Knottworks Construction, Inc.
PO Box 197
Otis, OR 97368
CCB #184887

Re: SPR 06SPR-23 2023.09.28 Incomplete Letter
Reed Road Site Plan Review application

In response to your Incomplete Letter referenced above, Knottworks Construction offers the following response / revision. Note, for ease of review, we indent and italicize our responses.

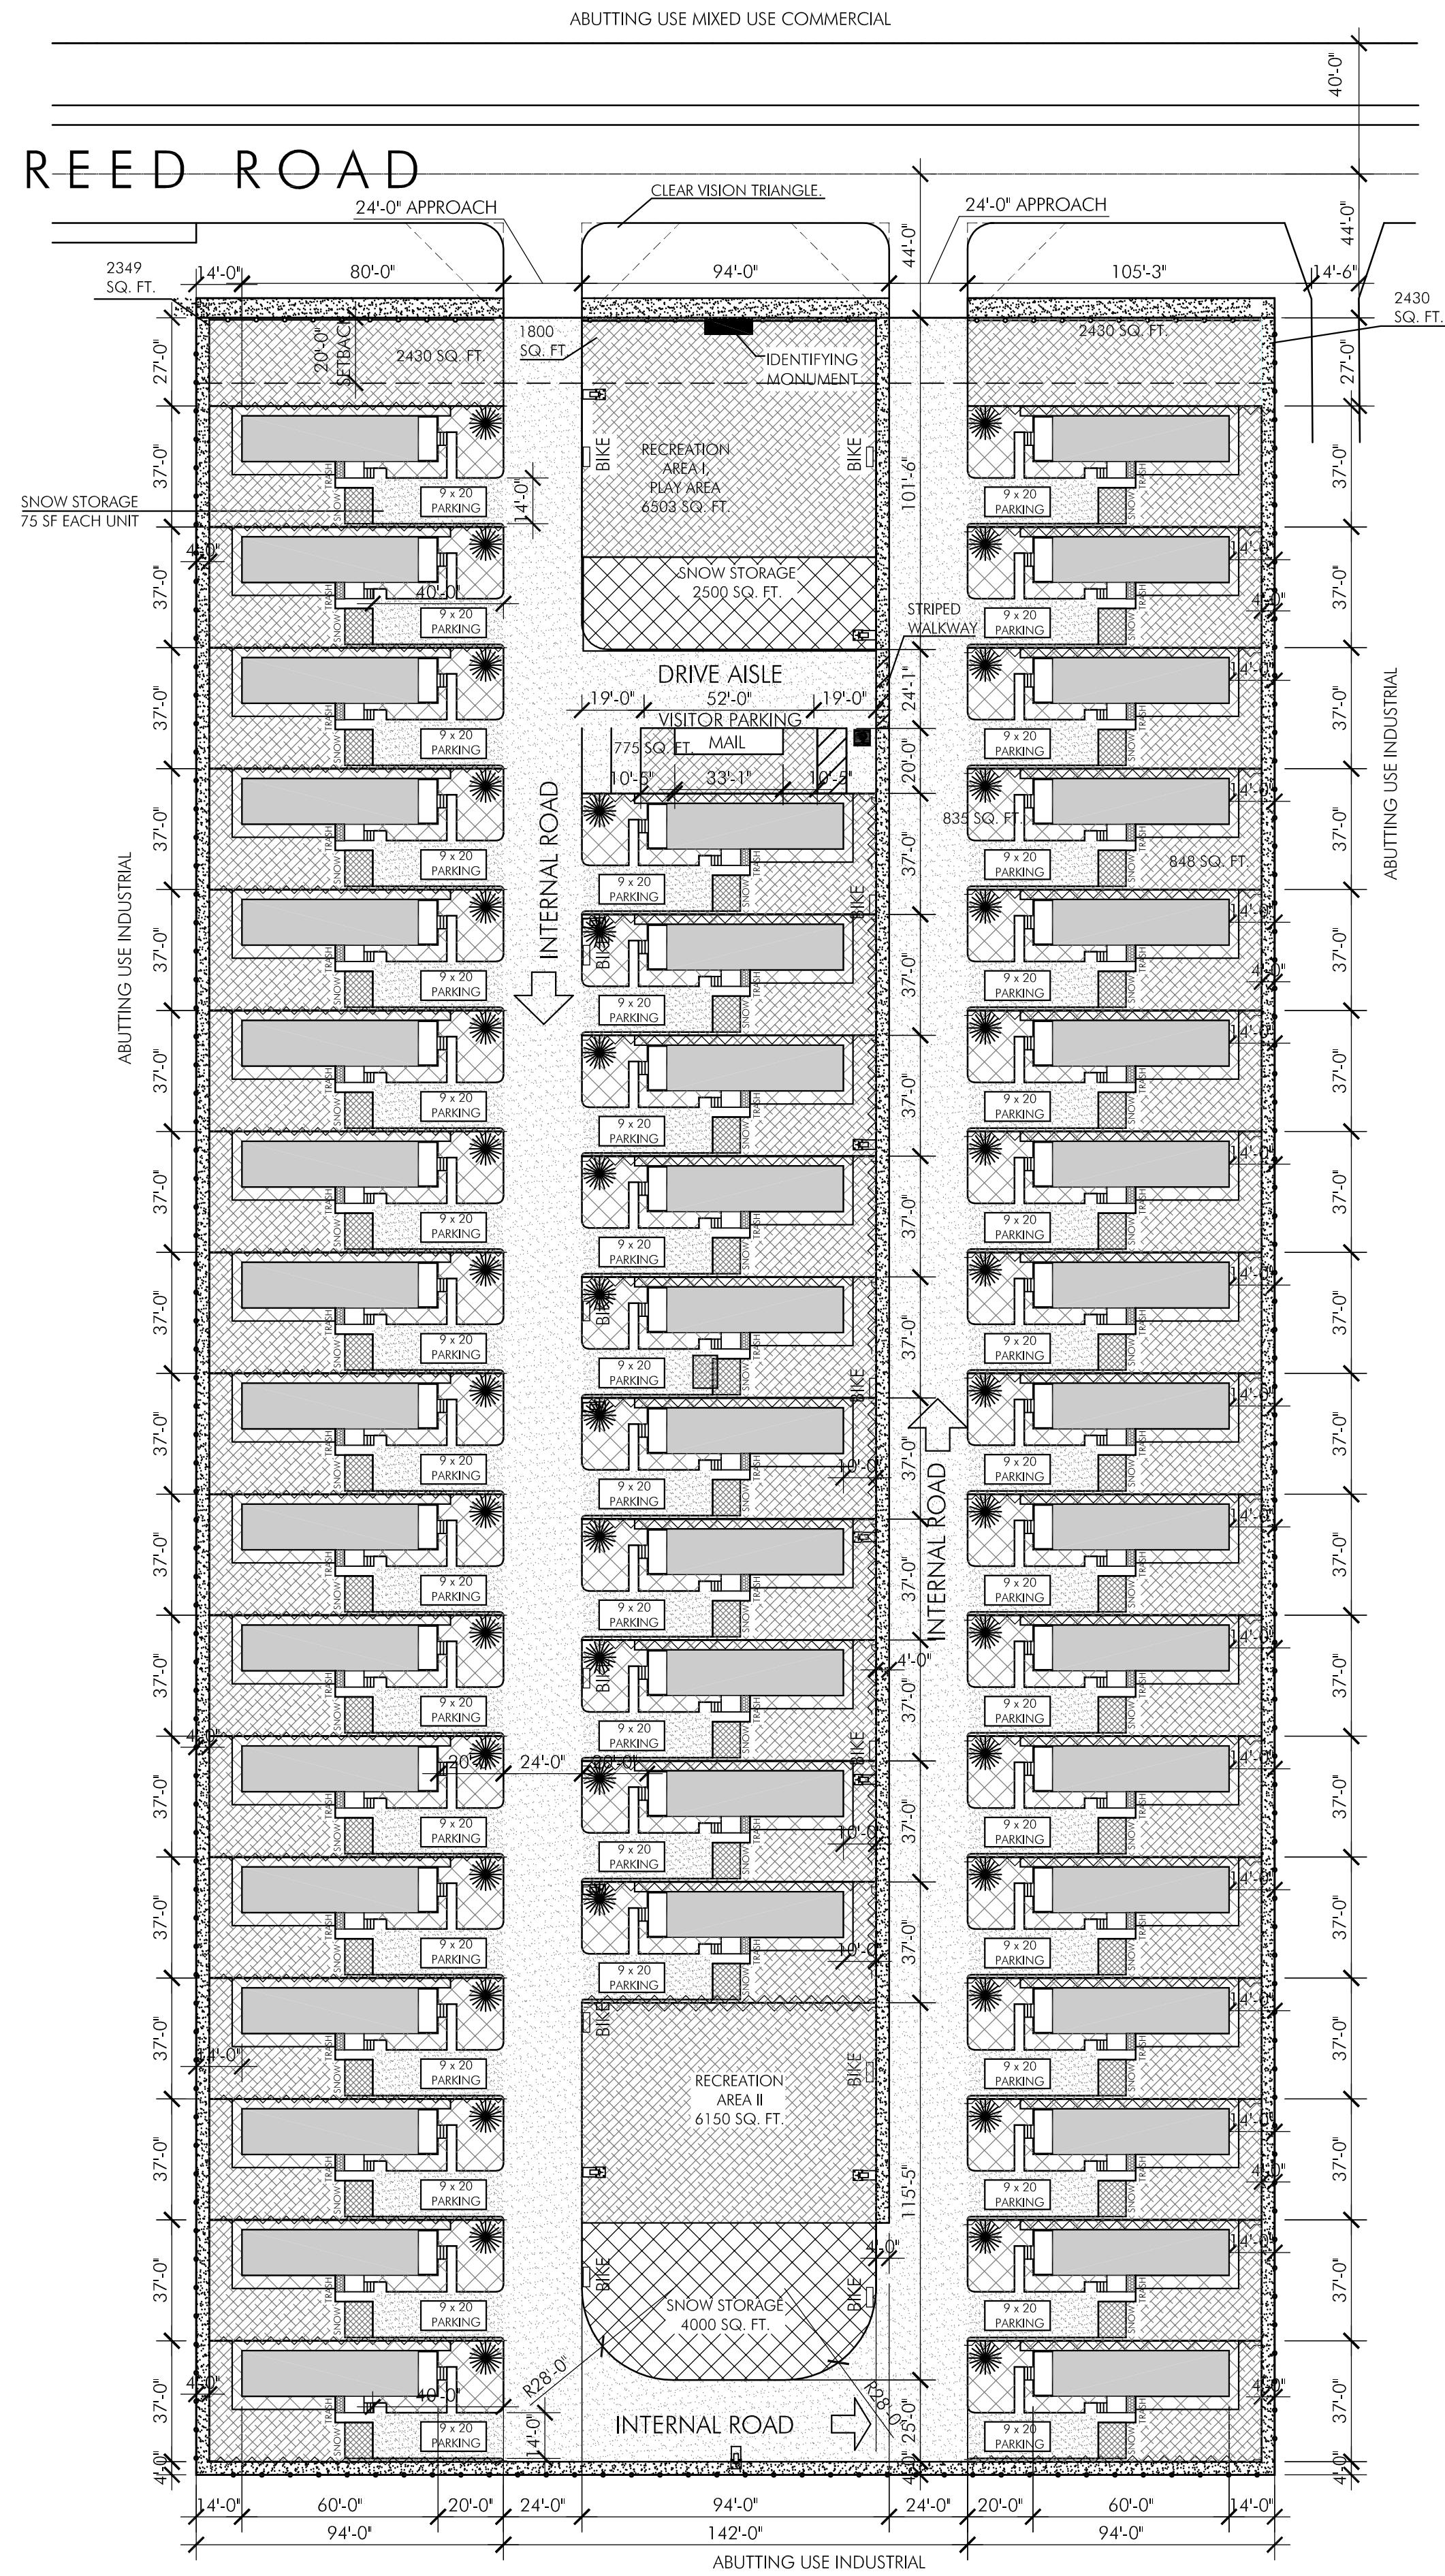
STAFF COMMENT: The applicant's burden of proof did not address this criterion. Please confirm who the parking spaces will be for and if fees will be charged. Also please confirm that the parking spaces will not be available to users off-site.

STAFF COMMENT: Based on Table 15.86-1, one parking space is required for each dwelling unit. The applicant's proposal includes 44 dwelling units and one parking space for each dwelling unit, as well as 10 additional parking spaces. While the 10 additional spaces and driveways are clearly labeled on the site plan, the individual parking space for each dwelling is not. Please update the site plan to have all parking spaces clearly labeled with dimensions.

STAFF COMMENT: The applicant proposes one way access aisles that will serve as a U-shaped internal roadway. The western side of the access aisle will be 30 feet in width, and the southern and eastern portion of the access aisle will be 20 feet in width. The driveways to access parking are at 90-degree angles and therefore access aisle must be at least 24 feet wide. Please update the site plan to meet these requirements so that the U-shaped internal roadway is at least 24 feet wide at all times.

STAFF COMMENT: The applicant's burden of proof and site plan did not address bike parking. Based on the proposal of 44 units, 11 bike parking spaces are needed. Please submit updated materials to reflect this requirement.

STAFF COMMENT: The applicant's burden of proof and site plan did not address bicycle parking design or hazards, please submit revised site plan and burden of proof which addresses these criteria.

STAFF COMMENT: The applicants site plan included the location of the snow storage area and that it would 6,961.5 square feet in area, however for staff to accurately confirm if the 15% minimum is met, the applicant must provide how much space on the submitted site plan is cleared or impervious surfaces.

STAFF COMMENT: Clear vision triangles were identified on the site plan, however staff could not determine the dimensions of the clear vision triangles to see if they complied with LPDC. Based on the right of way width, the clear vision triangle must be 30 feet. Please submit an updated site plan that includes dimensions.

STAFF COMMENT: The proposed pedestrian pathway fronts on the internal side of the U-shaped road, therefore, the residents on the opposite side will be required to cross the street to access the walkway. In light of this factor, please describe how the above criterion is met.

STAFF COMMENT: There are several areas in the site plan where the proposed pedestrian walkway crosses a driveway. The applicant's burden of proof and site plan did not address this criterion. Please describe how this criterion will be met.

STAFF COMMENT: There are multiple locations in the site plan where the pedestrian walkway crosses a driveway. The applicant's burden of proof and site plan did not address how this criterion would be met. Please describe how crosswalks will be clearly marked.

Applicant Response: *Parking will be only for residents and their guests. No parking spaces will be available to users off-site and no fees will be charged. Please see revised sheet A1.*

Applicant Response: *Please see revised site plan sheet A1. One parking space per unit is noted.*

Applicant Response: Please see revised site plan sheet A1. Internal roadway is revised to 24'-0" width.

Applicant Response: Please see revised site plan sheet A1. There are 12 bike loops proposed, interspersed among units as follows:

Applicant Response: Please see revised site plan sheet A1. There are 12 bike loops proposed, interspersed among units. Bike parking will consist of steel "U" racks, offering options for user-supplied lock.

Response: Please see revised site plan sheet A1 indicating snow storage areas. Areas to be cleared include Common asphalt area, 37,125 s.f. @15% = 5,569 s.f. required, 6,500 s.f. provided; and Unit asphalt coverage of 500 s.f. @15% = 75 s.f. required, 75 s.f. provided at each unit space.

Applicant Response: Please see revised site plan sheet A1, indicating 30 foot clear vision triangles.

Applicant Response: Please see revised site plan sheet A1. Pedestrians are provided a walk way behind units to access the public right-of-way, avoiding driveways and crossing the internal street.

Applicant Response: Please see revised site plan sheet A1. Pedestrians are provided a walk way behind units to access the public right-of-way, avoiding driveways and crossing the internal street.

Applicant Response: Please see revised site plan sheet A1. A striped walkway is provided where the walkway near visitor parking at the north central walkway where it crosses the drive aisle between the internal roadway.

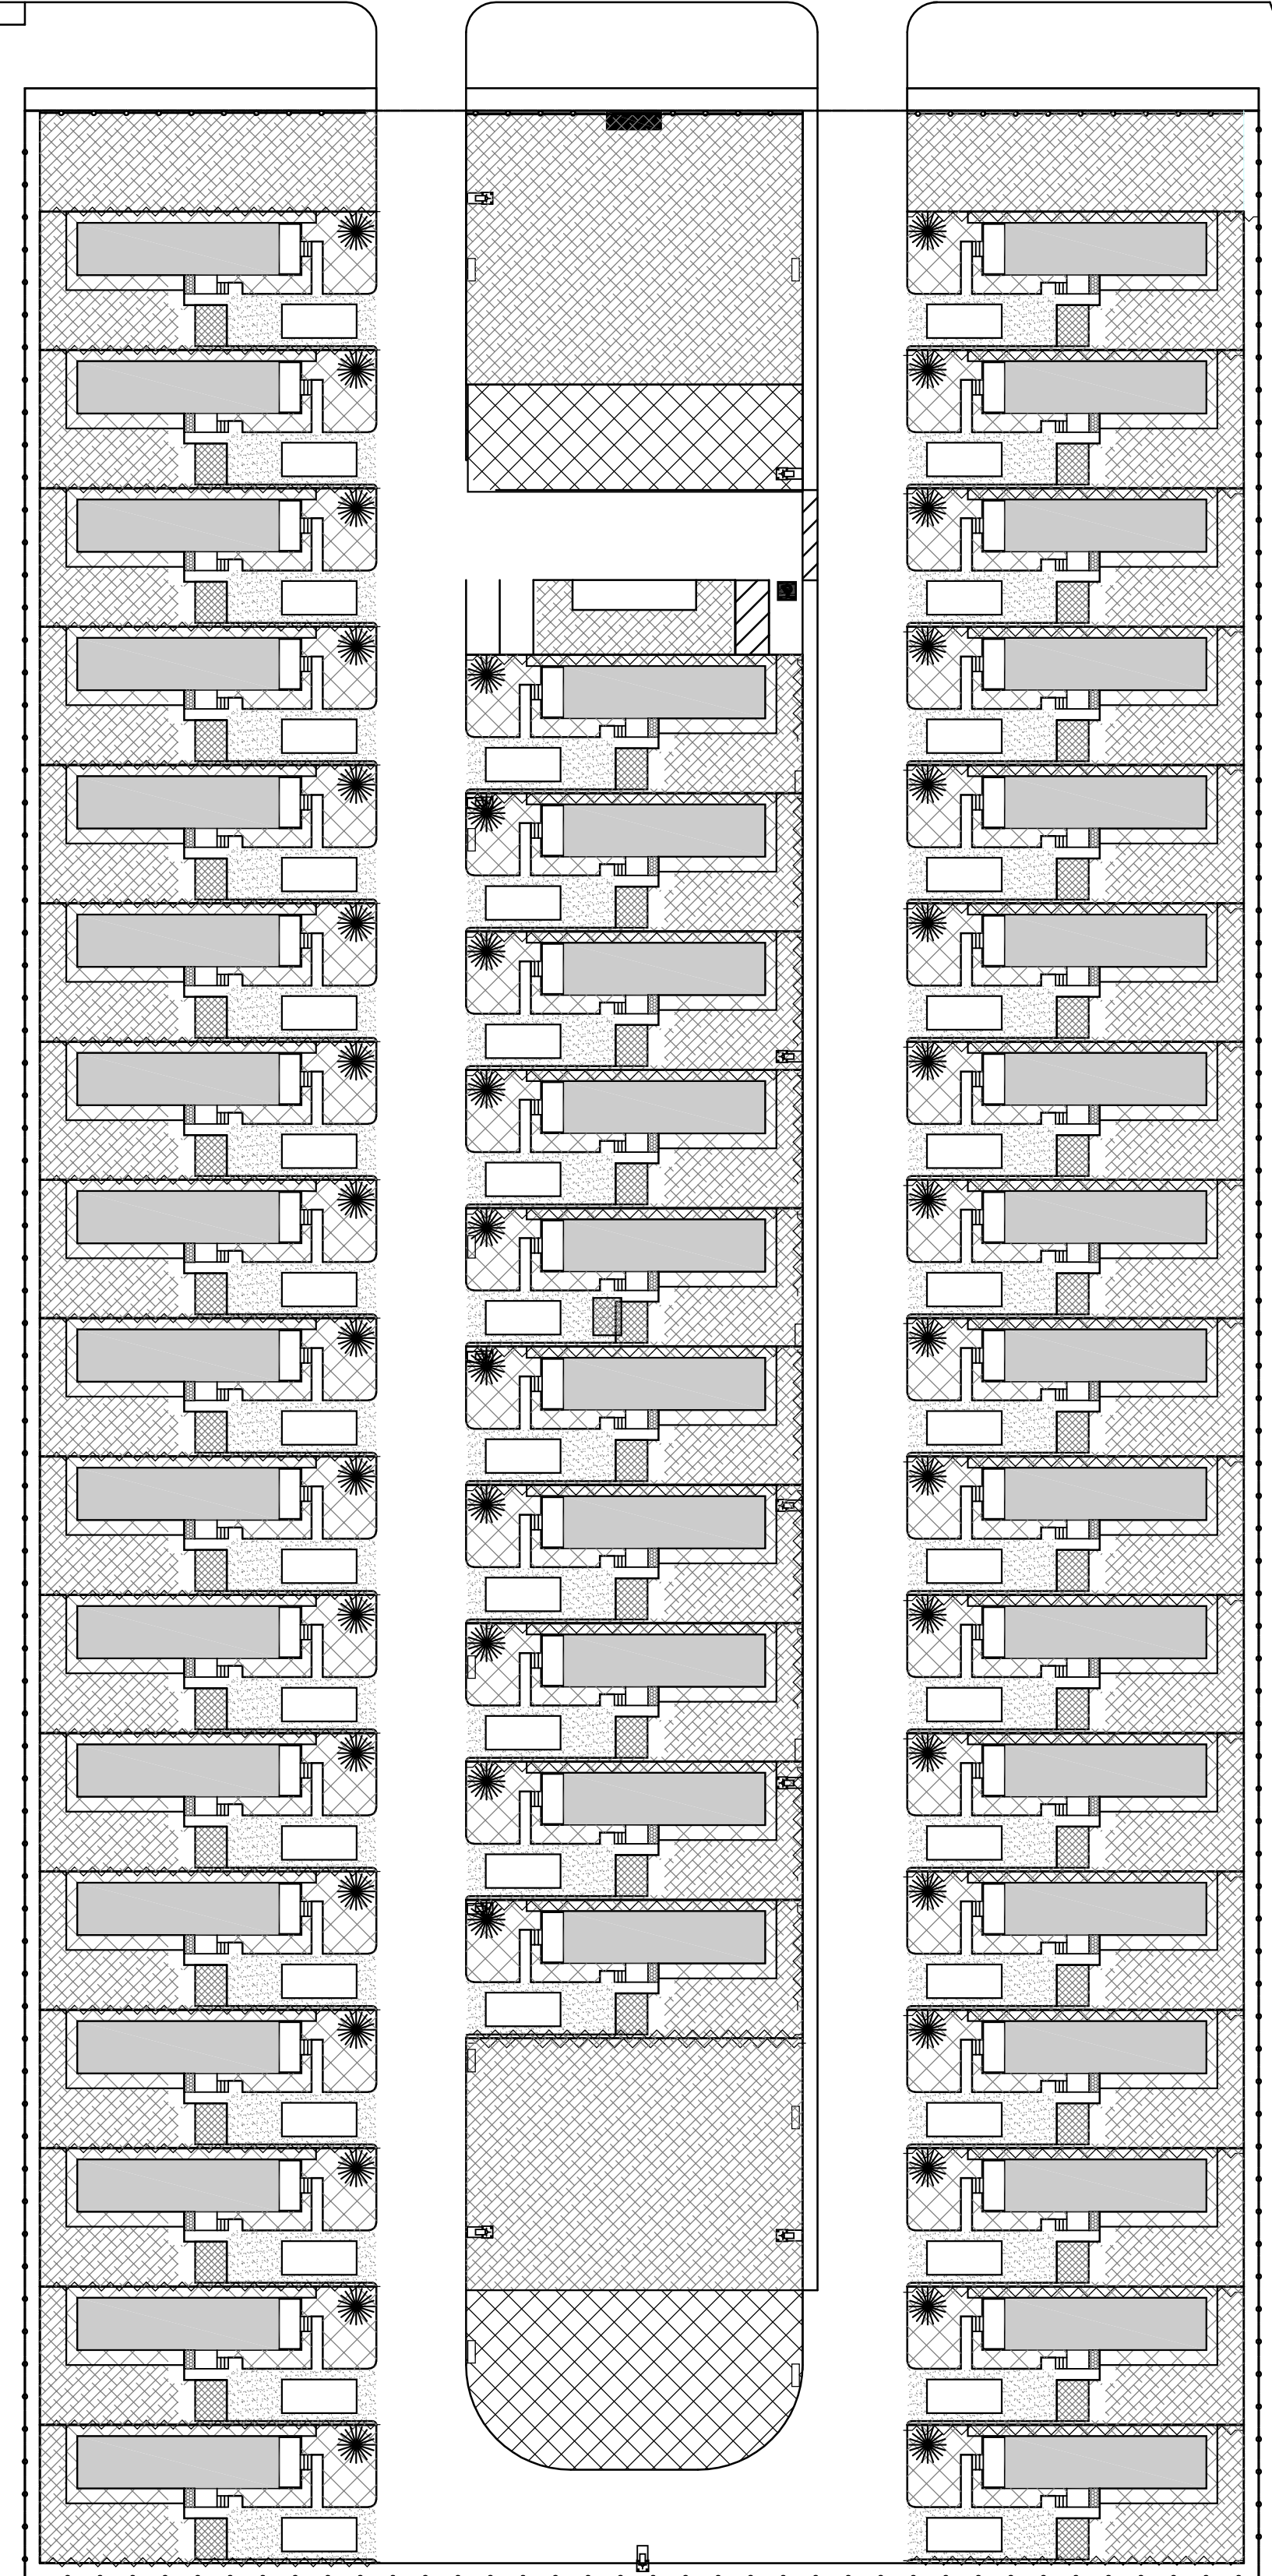
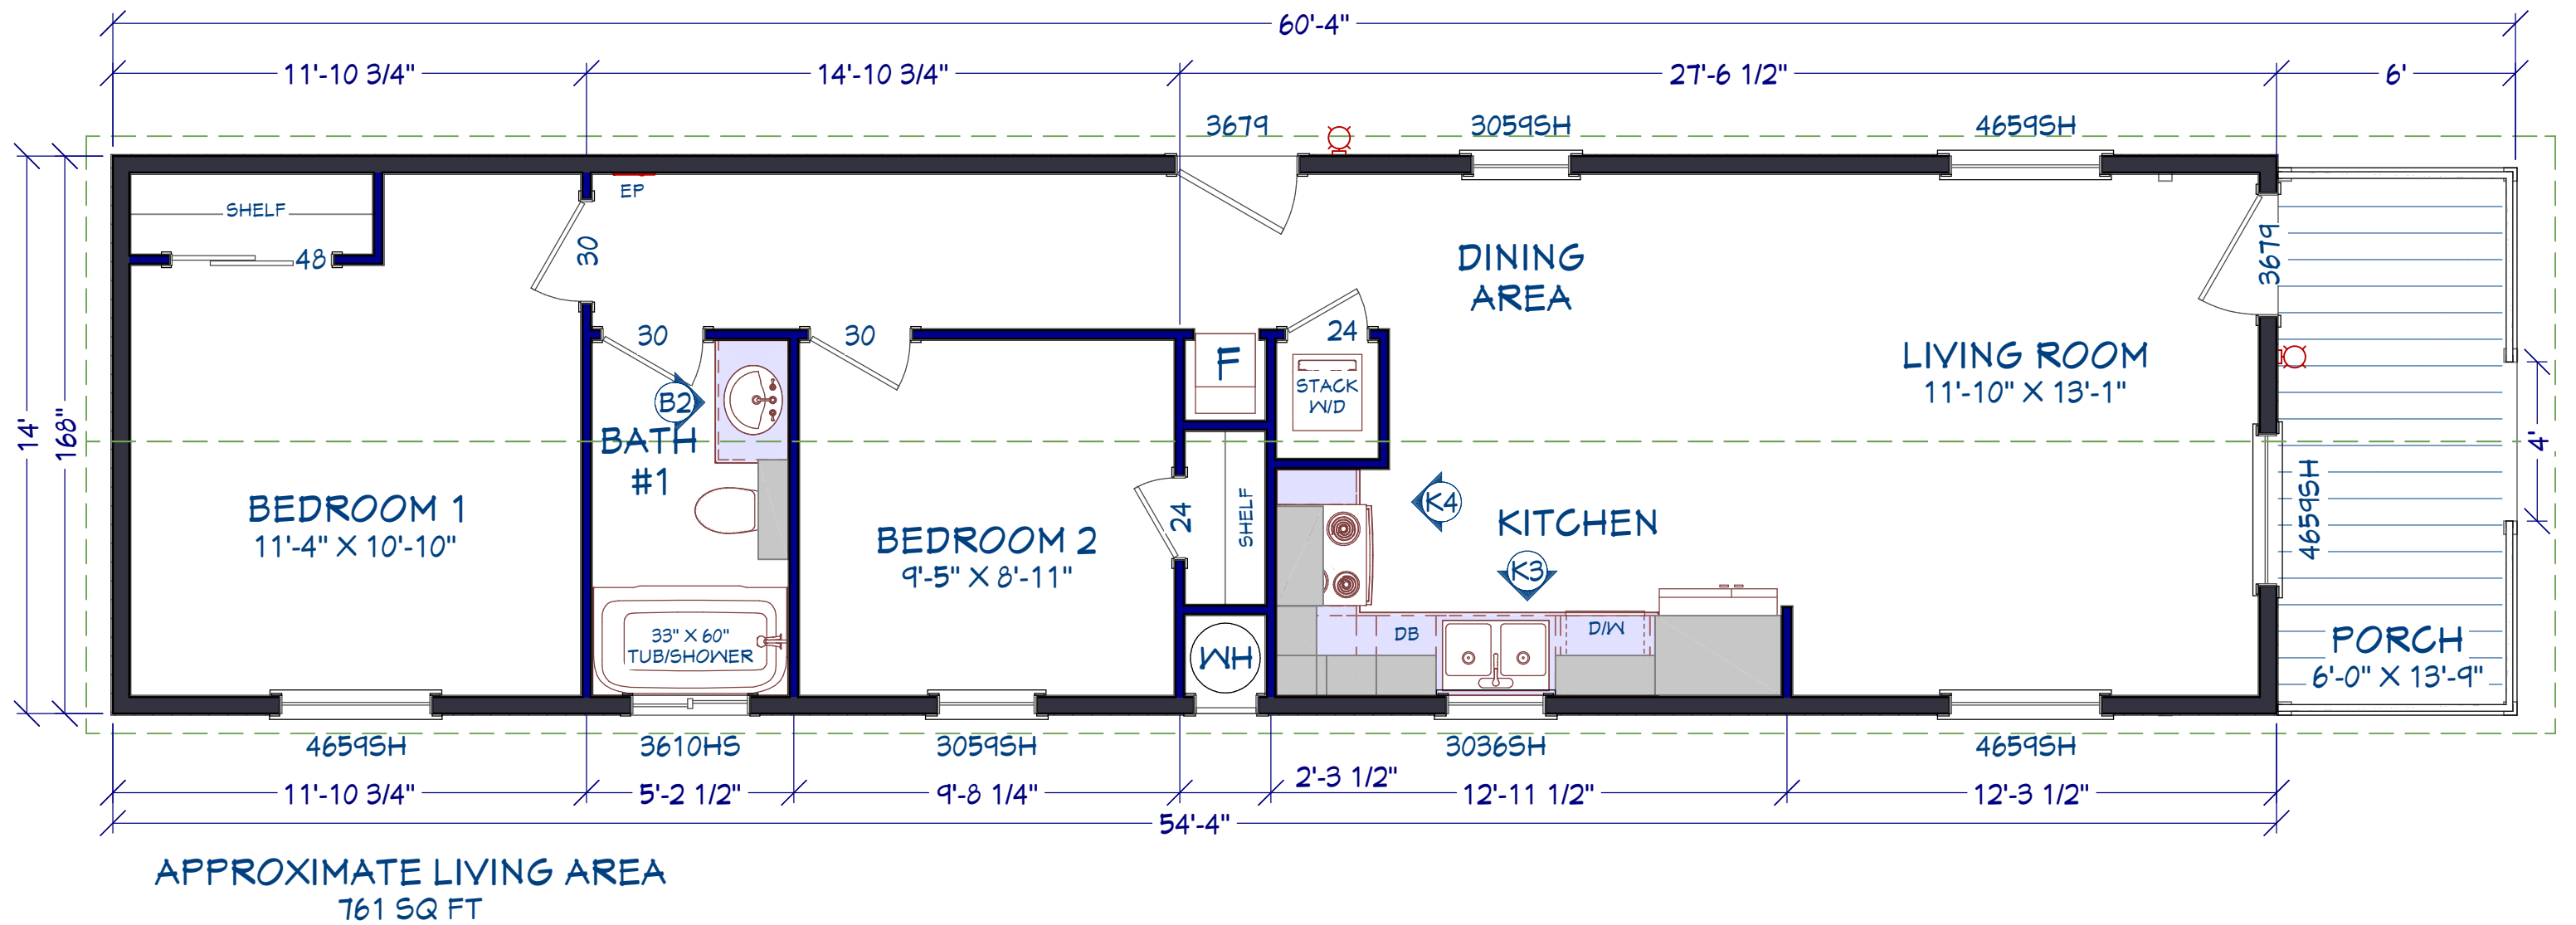
Based on the submitted information and site plan, staff cannot accurately confirm if the 20% standard of 06SPR-23, Knottworks landscaping is met. Please provide information on exactly how much of the subject property will be landscaped in square feet or acres. A separate site plan that details a landscape plan which highlights where different materials would be helpful to address this criterion as well as others in LPDC 15.82.

STAFF COMMENT: The applicant's burden of proof indicates that the materials used for landscaping will include grass, rocks, trees, shrubs, as well as other landscape materials as allowed by the development code. Please confirm how much of the total landscape area (1 acre required) will be living (trees/shrubs/grass) versus nonliving (rocks). Again, a separate landscape site plan would be helpful.

STAFF COMMENT: The applicant's burden of proof did not fully address the above criteria. Please address subsection G (1-4) and as stated previously, a landscape site plan may help address these criteria.

STAFF COMMENT: As stated previously, please submit a landscape plan that meets the above criteria so that staff can determine if the landscaping requirements of LPDC are met.

Applicant Response: *Please see attached landscape plan, sheet A2. Total landscaped area is 110,895 s.f., totals of rock vs. irrigated living plant material is noted. With an overall area of 217,800, this results in 50.9 % landscape coverage which exceeds the required 20%.*

Applicant Response: As noted above, please see attached landscape plan, sheet A2.

Applicant Response: Please see attached landscape plan, sheet A2 which notes the required standards.

Applicant Response: Please see attached landscape plan, sheet A2.
